# DEFENSE NUCLEAR FACILITIES SAFETY BOARD

## Staff Issue Report

**SUBJECT:** Air Pulse Agitator Controls, Salt Waste Processing Facility

Figure 1

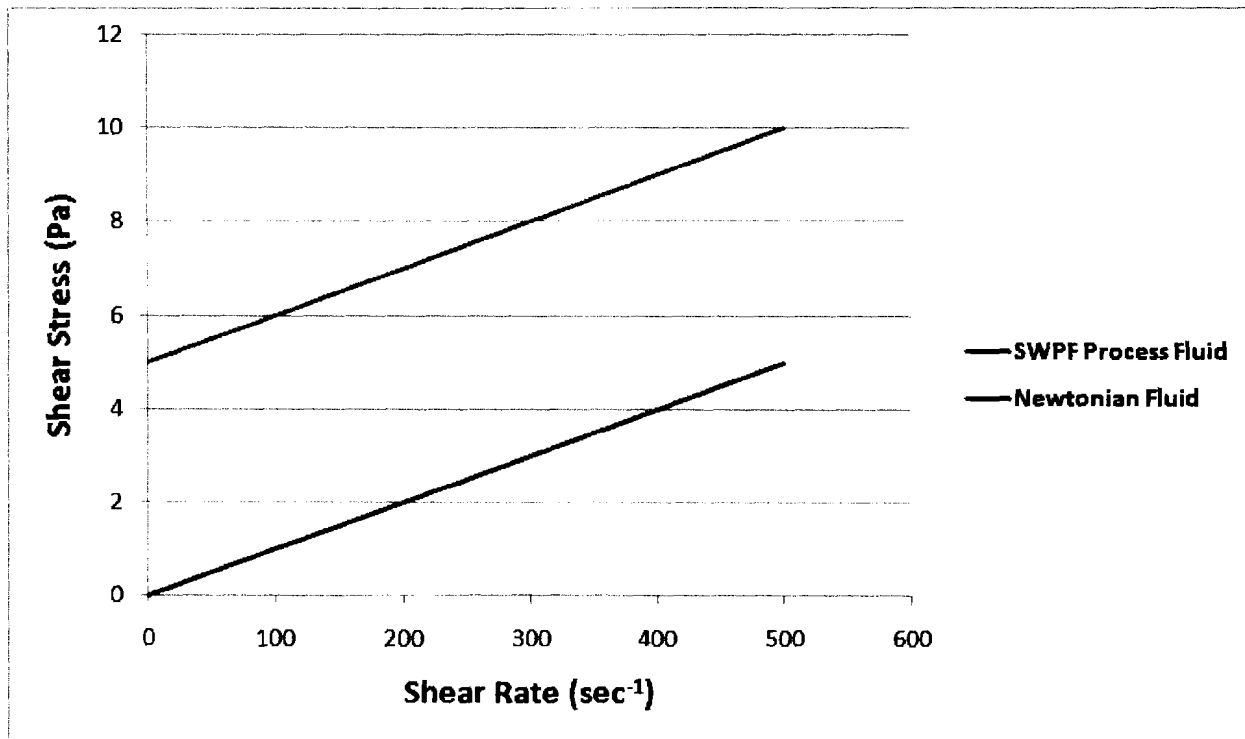
The design basis for the facility's process does not address the potential for a combination of waste sludge and monosodium titanate exhibiting thixotropic behavior after settling.<sup>4</sup> The potential for this behavior is described in a study of the rheological characteristics of mixtures of monosodium titanate and sludge simulant. Failure to consider the potential for thixotropic behavior in the design of the air pulse agitators could result in the inability to fully resuspend solids following periods without agitation.
